# Staff Report to the Ogden Valley Planning Commission

<b>Application Request:</b>	Consideration and action on a conditional use permit application for 50 self storage units located at approximately 601 South 7800 East, Huntsville, UT.
<b>Type of Decision:</b>	Administrative
<b>Agenda Date:</b>	Tuesday, September 26, 2017
<b>Applicant:</b>	Kerry Wangsgard
<b>Authorized Agent:</b>	Chris Cave, Reeve and Associates Inc
<b>File Number:</b>	CUP# 2017-06

The Planning Division recommends approval of file# CUP 2017-06, a conditional use permit application for 50 self storage units located at approximately 601 South 7800 East, Huntsville, UT, on parcel 24-018-0007. This recommendation for approval is subject to all review agency requirements and with the following conditions:

**CUP Site Plan**

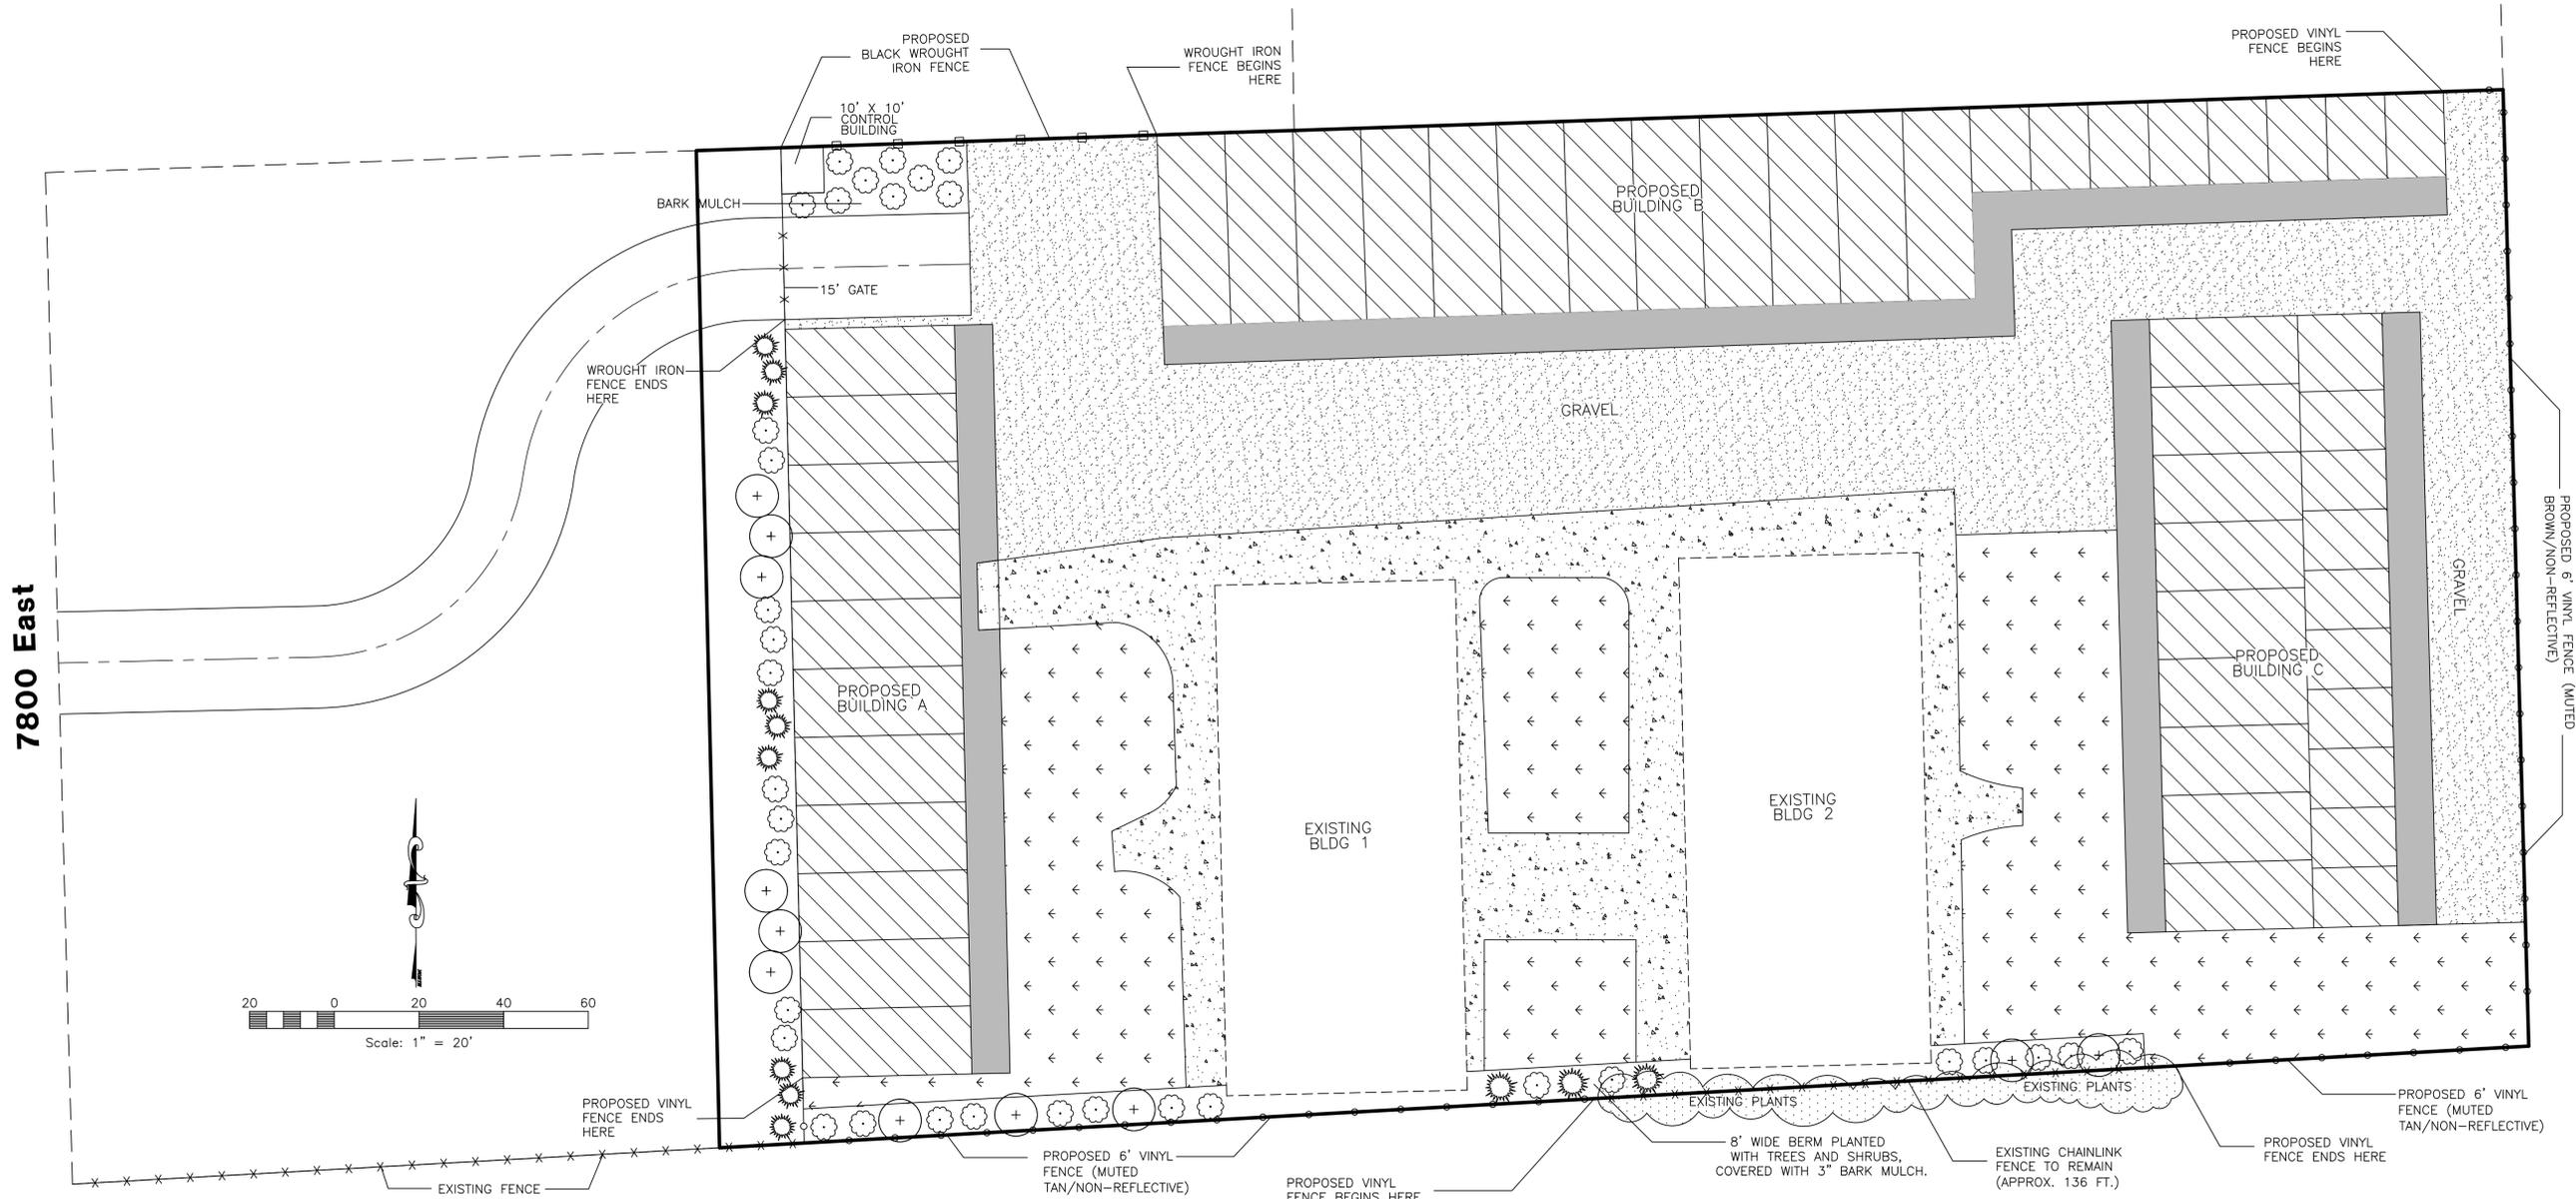
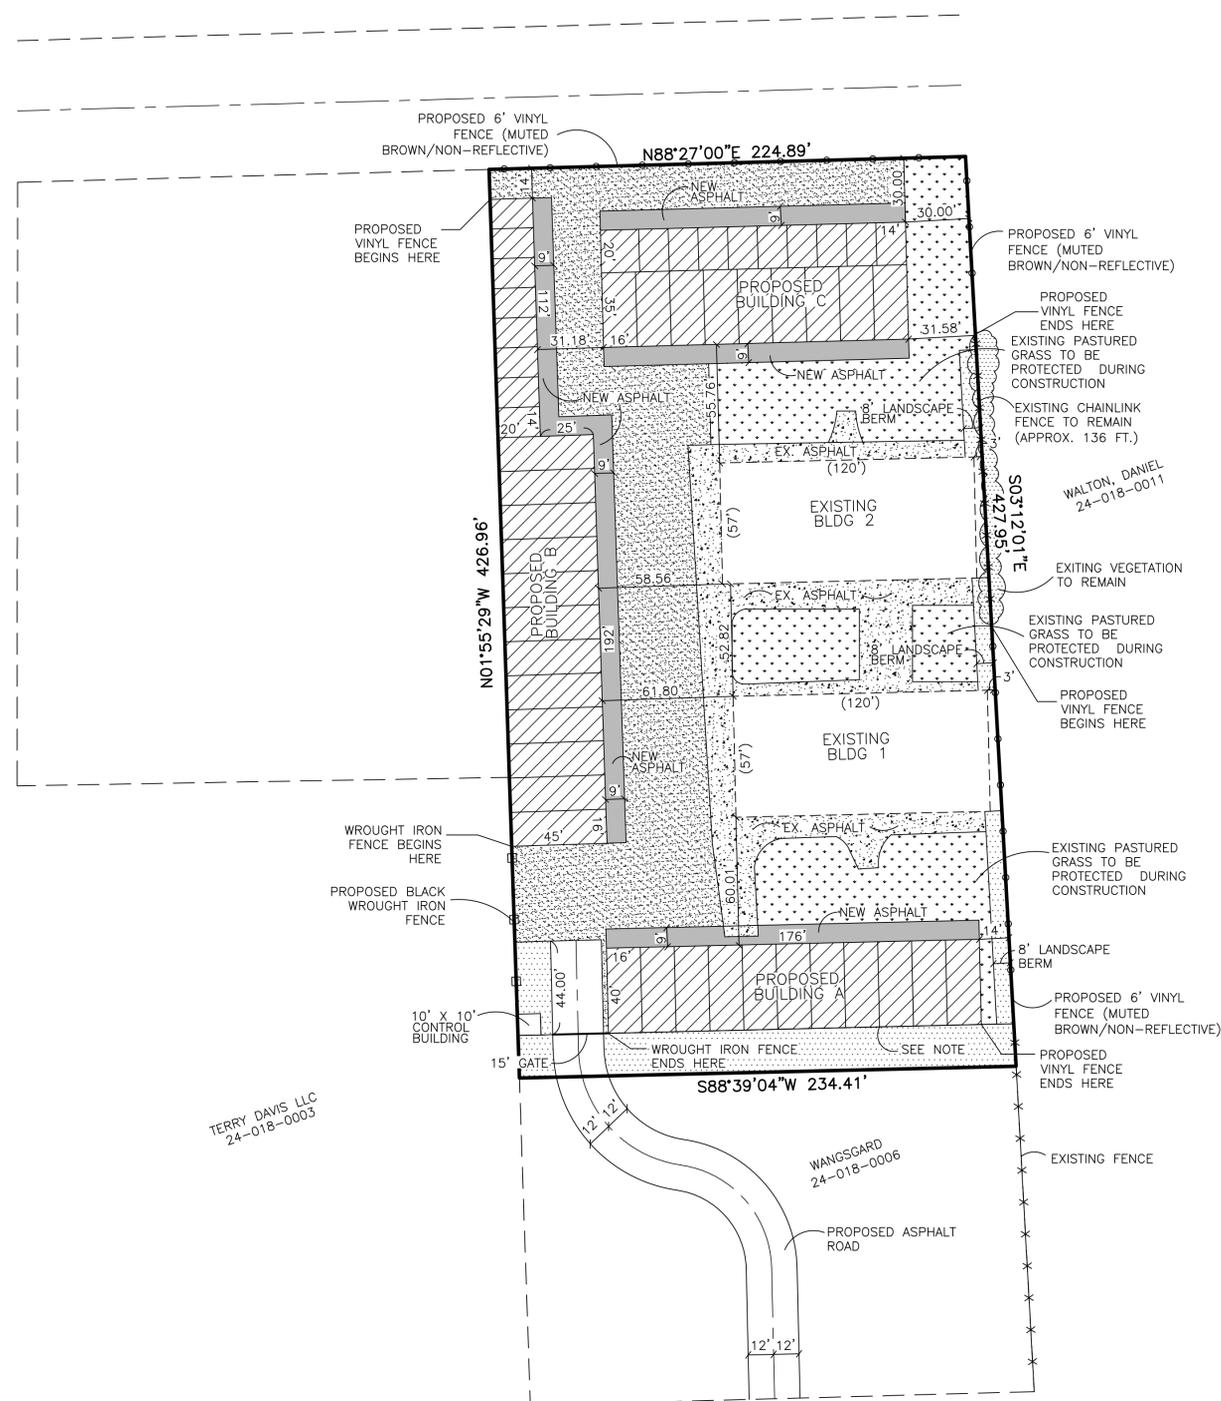
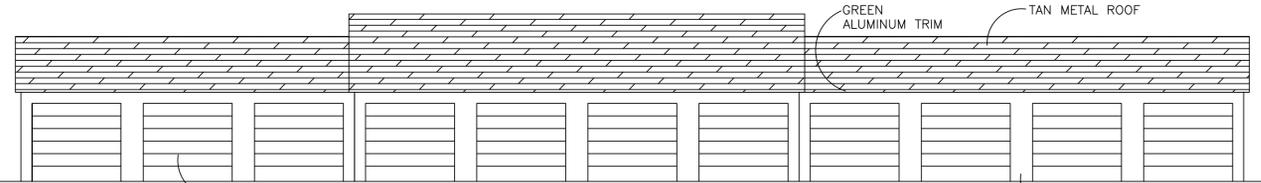
Building A will be located 20' from the front property line and 14' from the side property line adjacent to an agricultural zone; Building B will be located along the side property line that abuts the CV-2 zone. The end of 'Building B' will be 14' from the side property line that is adjacent to the agricultural zone; Building C will be located 30' from the rear and side property lines that are adjacent to the agricultural zones. The proposed buildings, according to the site plan, are in compliance with the site development standards of the CV-2 Zone.

- *Considerations relating to traffic safety and traffic congestion.* As part of this consideration, the applicant has provided a detailed site plan (see Exhibit B). A condition of approval has been added to the Planning Division's recommendation to ensure the requirements of the Utah Department of Transportation are met prior to the issuance of a land use permit for the construction of the new buildings.

The applicant is proposing a 19,151 square foot gravel driving/unloading area for the new buildings. The proposed gravel will need to consist of the appropriate gravel size so as to mitigate traffic hazards and

nuisances such as dust. The existing site includes concrete driving areas for parking at the previously existing storage units. A 9' wide concrete strip will be located along the frontage of each of the proposed buildings, providing the hard surface parking requirement outlined in LUC §108-8-7.

- *Considerations relating to buildings and site layout.* The proposed buildings meet the site development standards of the CV-2 Zone. The site plan shows that the new buildings will consist of light beige CMU walls, off white metal doors, tan metal roof, and green aluminum roof trim, conforming to the architectural standards outlined in LUC §108-2-4(1). The proposed parking area for the existing buildings will be screened from the adjacent AV-3 zone as required by LUC §108-2-7(b). The screening along south property line includes a 6' vinyl fence that will be muted tan and non reflective and an 8' wide berm planted with trees and shrubs, covered with 3" bark mulch, as shown on the landscaping plan. The rear side of Proposed Building A will face toward 7800 East and will be required to meet the architectural standards outlined in LUC §108-2-4 (2). The applicant will be required to provide architectural details at focal points on all new buildings to ensure that monotonous horizontal lines greater than 50 ft are avoided, as outlined in LUC §108-2-4 (8). A condition of approval has been added to the staff recommendation to ensure that these standards are met prior to issuance of a land use permit for the construction of the new buildings.

A 15' wide code access gate will be located along the front access of the facility to allow 24/7 access to customers. The applicant has also proposed a black wrought iron fence along the front and north side property lines. The gate and wrought iron fence shall not exceed 6' in height, as stated in LUC §108-7-3.

3. The applicant will be required to submit a revised site plan, showing how the existing landscaping will be protected from customer vehicle access by sod blocking or another method approved by the Planning Division.

4. The rear side of Proposed Building A, facing toward 7800 East, will be required to meet the architectural standards outlined in LUC §108-2-4(2).
5. The applicant will be required to provide architectural details at focal points on all new buildings to ensure that monotonous horizontal lines greater than 50 ft are avoided, as outlined in LUC §1082-4(8).

6. Additional coniferous trees shall be planted along the rear side of Proposed Building A to ensure that the view corridor of the valley is protected year round from the addition of the new buildings.

7. The Planning Division must approve of the gravel size and material that will be used for the driving/unloading area, prior to commencement of the project.

8. The proposed fencing must not exceed 6 ft in height, as outlined in LUC §108-7-3.
9. Prior to the issuance of a conditional use permit, the existing outdoor storage of boats, trailers, and any other outdoor storage must be removed from the parcel used to access the property.

**Landscape Plan**

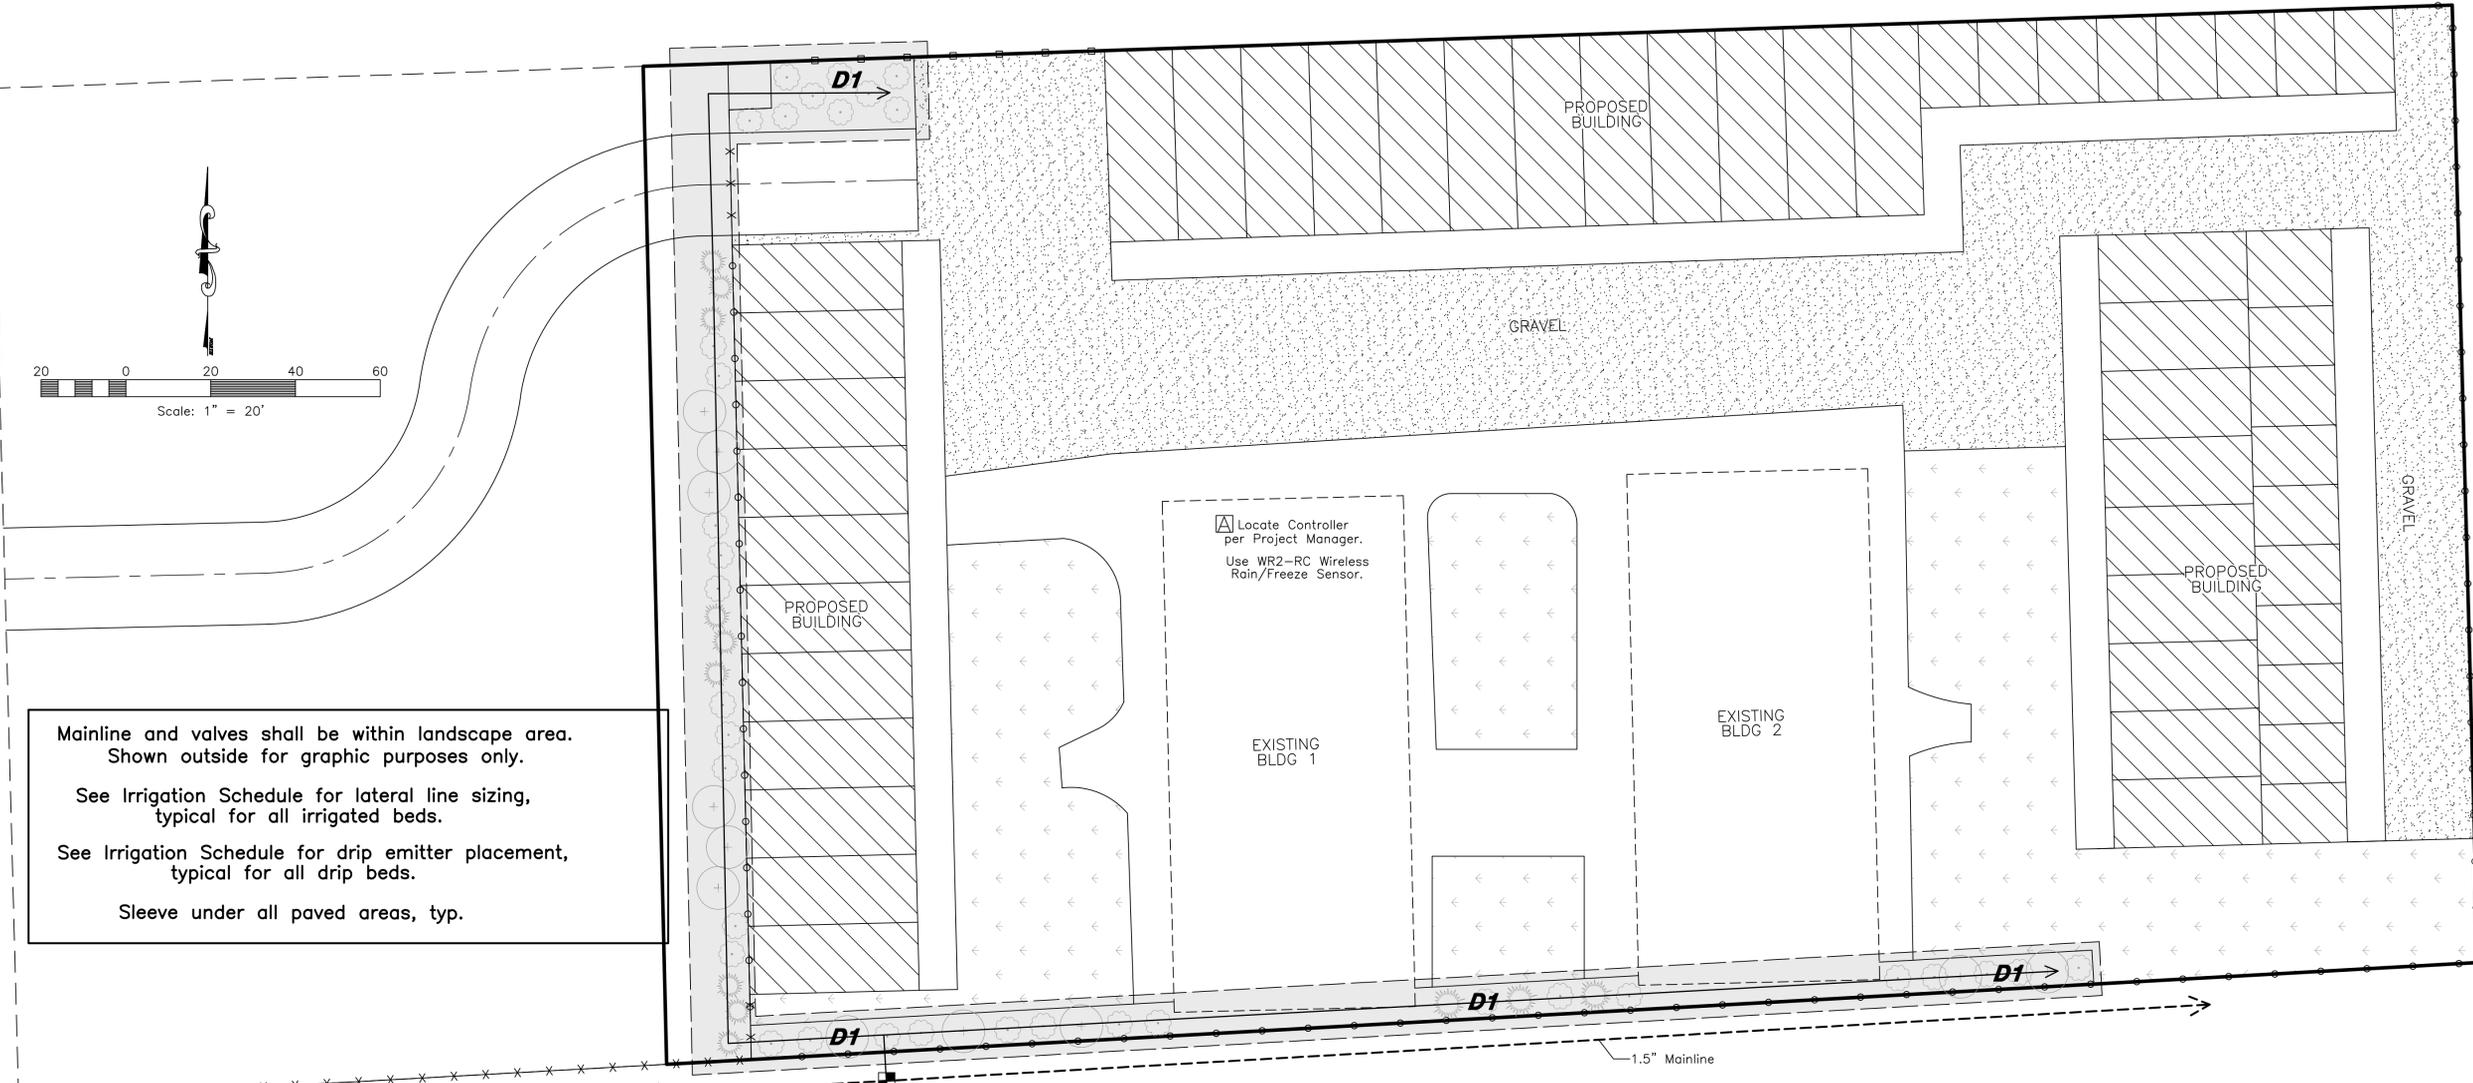
- *Considerations relating to landscaping.* The applicant's site plan and landscaping plan show that the project area will meet the 20 % landscaping requirement outlined in LUC §108-2. The proposed landscaping includes existing pastured grass (to be protected during construction). The applicant will be required to submit a landscape maintenance plan to ensure that the existing field grass is maintained in good condition so as to provide a neat and orderly appearance, free from weeds, as stated in LUC §108-2-5(i). The existing field grass landscaping is currently being driven on as part of the current operation. Because the existing field grass is proposed to be part of the 20 % landscaping requirement for the new buildings, the applicant will be required to submit a revised landscaping plan, showing how the existing landscaping will be protected from vehicle access.

The landscaping plan also includes multiple coniferous and deciduous trees and multiple shrub plantings. The applicant plans to irrigate the new trees and shrubs through a pressurized irrigation system, as shown on the irrigation plan.

1. All State, Federal and County standards, including UDOT's standards, will be met prior to issuance of a land use permit.
2. The applicant will be required to submit a landscape maintenance plan to ensure that the existing field grass is maintained in good condition so as to provide a neat and orderly appearance, free from weeds, as stated in LUC §108-2-5(i).
